OMRON

Product Discontinuation Notices

No. 2010297E

Discontinuation Notice of Handy Terminal model V680-A-7527S-G2 series

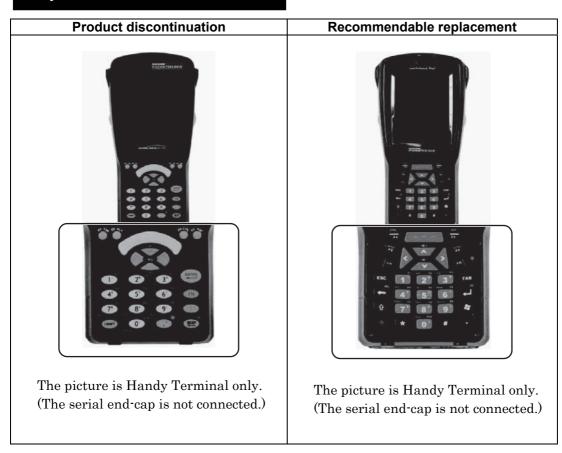
There is no change as follows;
- The brand of these products is PSION Teklogix.
- The software (Easy Access and CB Access) is preinstalled.
- The following products are compatible with V680-A-7527S-G3 series.
    - model V680-A-CA1053
    - model V680-A-WA3006
    - model V680-A-WA4003

- model V680-A-WA6197
